CONOCO

January 20, 1981

Re: Responses to Ott Water Engineers Comments on Hydrological Methodology - Sand Rock Mill Project - NRC Docket No. 40-8743

Figure 1 - THEIS WELL FUNCTION VERSUS INVERSE OF THE WELL FUNCTION VARIABLE

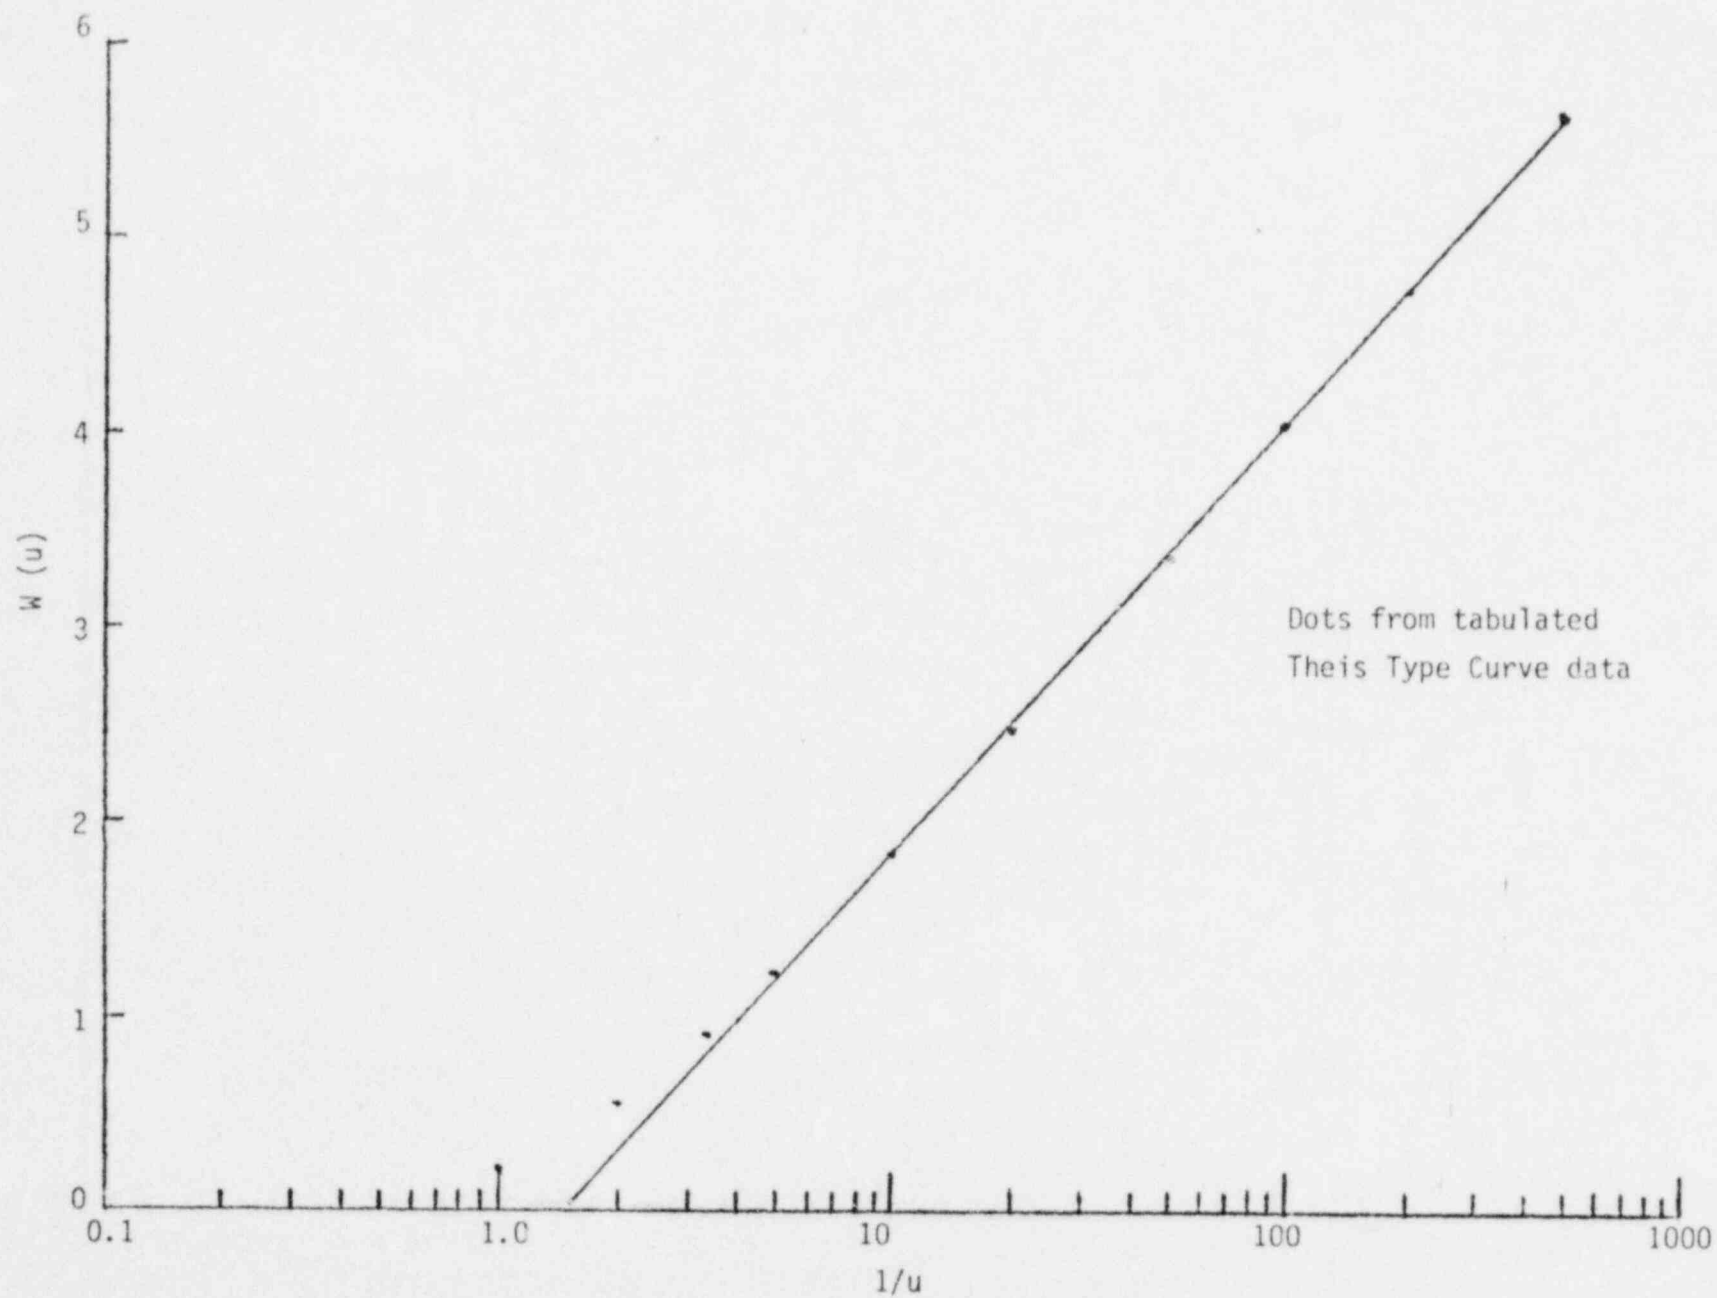
On October 31, 1980, Conoco staff members discussed hydrological methods with you and your consultants (Ott Water Engineers) regarding procedures used by Conoco in the Sand Rock Mill Environmental Report. After careful study and consideration of the questions raised, Conoco is offering the following commentary.

A plot of the well function, $W(u)$, and the inverse of the well function variable, $1/u$, shows that one should expect the straight line to be applicable near a u value of 0.1 (see Figure 1). Even the $1/u$ value of 5 (u of 0.2) plots very close to the straight line. Therefore, Theis' theory shows that the straight line method should be applicable for u values less than 0.1, instead of the 0.01 which Jacob recommended.
